PREPARED	NAME	PAZMANY AIRCRAFT CORPORATION — SAN DIEGO — CALIFORNIA —	MODEL NO.	PL-9
CHECKED		ENGINEERING CHANGE NOTICE 3	REPORT NO.	
APPROVED			PAGE NO.	1

DWG 9-10-002-SHT 1

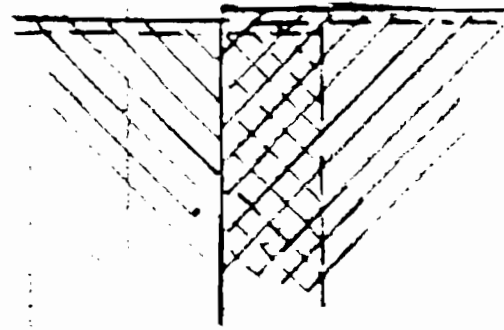
ZONE 6-B.

ZONE 4-B

END OF SKIN

-99

118.50

END OF SKIN

-101
